Contract #: 04-0120F4Cty: SF/ALA Rte: 80 PM: 13.2/13.9File #: 69.25B**QUALITY ASSURANCE -- NON-CONFORMANCE REPORT****Location:** Changxing Island, Shanghai, P.R. China**Report No:** NCR-000302**Prime Contractor:** American Bridge/Fluor Enterprises, a JV**Date:** 11-Jun-2009**Submitting Contractor:** Zhenhua Port Machinery Company, Ltd (ZPMC), Changxing Island**NCR #:** ZPMC-0276**Type of problem:****Welding****Concrete****Other****Welding****Curing****Procedural****Bridge No:** 34-0006**Joint fit-up****Coating****Other****Component:** OBG Segment 4AE**Procedural****Procedural****Description:****Reference Description:** Unapproved Heat Straightening, Segment 4AE**Description of Non-Conformance:**

## NON-CONFORMANCE REPORT TRANSMITTAL

**Reference Description:** Unapproved Heat Straightening, Segment 4AE

PROJECT: SAN FRANCISCO OAKLAND BAY BRIDGE

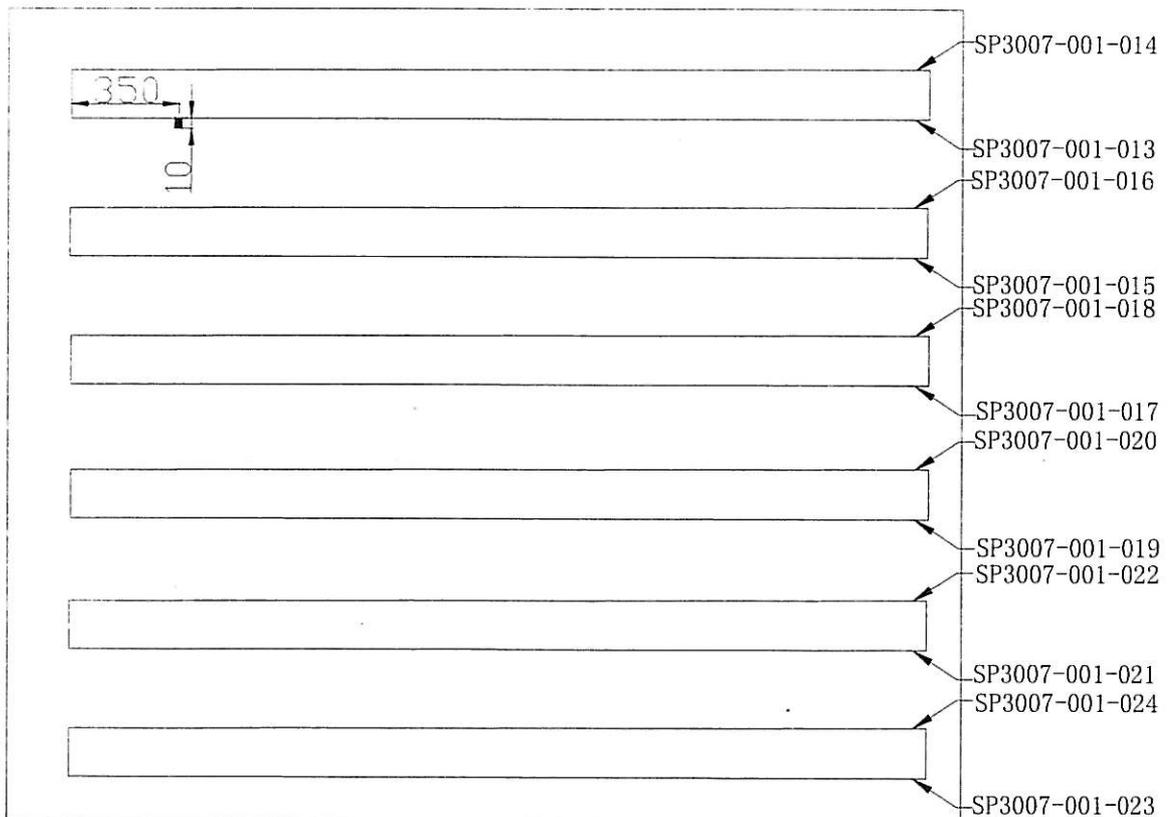
在对SP3007-001-013检测时,发现1处横向裂纹。1、L=10mm。

One transverse crack was found by use of MT on weld(SP3007-001-013).

1. Moisture wasn't completely removed during drying operation (preheating) or the area wasn't preheated sufficiently.

1. QC and a Lead CWI shall be present, direct and supervise all grinding and welding operations during this repair to ensure the repair is per the disposition requirements.

2. QC and a Lead CWI shall have an approved copy of the CWR in hand prior to the repair.
3. Remove cracks only by use of grinding, If gap > 5mm is found while grinding, seek approval from engineer before next operation.

4. Remove paint  $\geq 25$ mm in all direction of HAZ prior to MT.
5. Perform hardness testing at repair area and base metal laying abroad cracks, provide verbal and written notification to Engineer prior to performing hardness testing, and submit the testing result to Caltrans for review prior to repairing after testing.

6. Prepare excavation in accordance with an approved repair WPS prior to welding.
7. Before this repair, Verify with VT and MT repair areas are defects free, and also MT shall be performed on the base metal laying abroad cracks to ensure that no cracks were propagated to the base metal. Separate CWR approval is needed if cracks are found in the base metal.

8. Preheat and weld according to the approved repair WPS.
9. Grind the repaired area flush with base metal or the adjacent weld.
10. Perform relevant NDT inspection (UT and MT must be performed for SRM members in accordance with Section 3.2.2.3 of AWS D1.5 after repair) to all repaired welds as well as the welds which are in the opposite position of the repaired welds according to shop drawing and additional NDT requirement stated in special provision 10-1.59 "inspection testing" note 3 after repair.

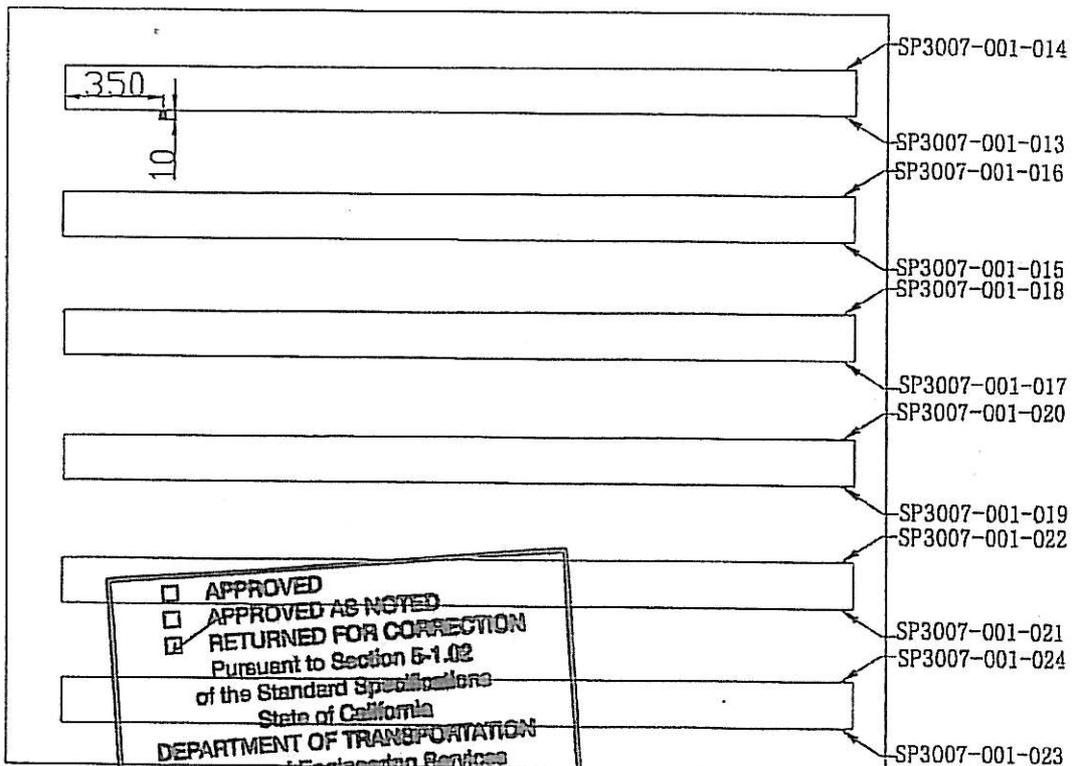
1.	<input type="checkbox"/> Yes <input checked="" type="checkbox"/> No	SP3007 Transverse crack

-Hardness testing is required at the transverse crack location prior to excavation and repair. The readings of the hardness testing shall be done along the weld and the adjacent base metal (the flange and the U-rib diaphragm).

-Provide written and verbal notification to the engineer prior to the hardness testing for engineer to witness the testing.

-The result of the hardness testing shall be submitted to Caltrans for review prior to repairing.

-Separate CWR approval is needed if cracks are found in the base metal heat affected zone.

-If excessive root gap (5mm or more) is found during grinding of the repair area, the contractor shall seek the engineer's approval prior performing further repair. Contractor shall also provide the locations of these findings in submitting a written document and marking the actual data on the steel surface.

-In disposition #2, gouging shall NOT be used for this repair.

*See TC-20*  
*- Hardness requirement*  
*- Notification of testing*  
*- Result of testing*  
*- HAZ CWR*  
*- Gap of 5mm*

*Gouging shall not be used.*

1. The Engineer shall be notified and present during this repair. Indicate repair procedure, *used.*
2. QC and a Lead CWI shall be present and direct all gouging, grinding and welding operations during this repair.

3. QC and a Lead CWI shall have an approved copy of the CWR in hand prior to the repair.
4. QC and a Lead CWI shall direct the repair to ensure the repair is per the disposition requirements.

5. Paint shall be removed in the area requiring MT;
6. Remove the crack by means of grinding.
7. Prepare excavation according to the approved repair WPS.

8. Before this repair, Verify with VT and MT repair areas are crack free, and also MT shall be perform on the base metal nearby transverse cracks to ensure that no cracks we re propagated in to the base metal;

9. Preheat and weld according to the approved repair WPS.
10. Grind the repaired area flush with base metal or the adjacent weld.
11. Perform VT after repair and additional% NDT requirement stated in special provision on 10-1.59 "inspection testing" note 3;

12. 100%MT all these welds after the weld repair, including the opposite side of the repaired weld that didn't require repair previously.

Report No: NCR-000302

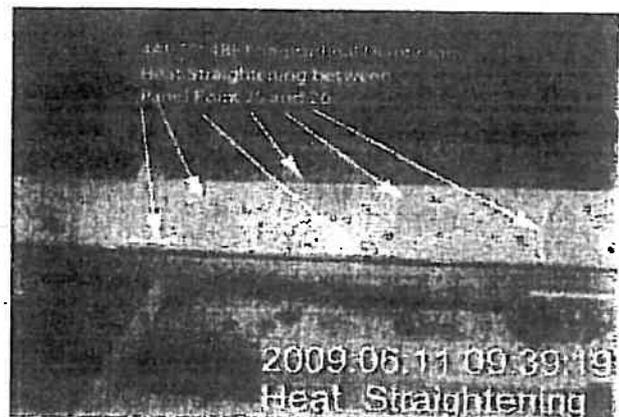
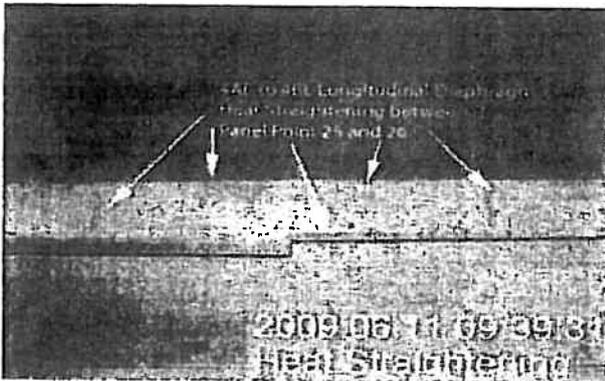
Caltrans Quality Assurance (QA) Inspector observed deflection and distortion in the longitudinal diaphragms (LD)s located at the 4AE/4BE segment splice (between PP25 and PP26). Heat straightening was being performed on LD008-001 (Segment 4AE) for the second time without an approved heat straightening report and without the Engineer's approval.

AWS D1.5 2002 Section 3.7.3: "Members distorted by welding shall be straightened by mechanical means or by carefully supervised application of a limited amount of localized heat as approved by the Engineer."

Special Provisions 8-3-01 Welding Quality Control: "The Engineer shall be notified immediately when weld distortion occurs that cannot be corrected using the standard procedures for heat straightening submitted in the WQCP. Request to heat straighten shall be in writing and include.
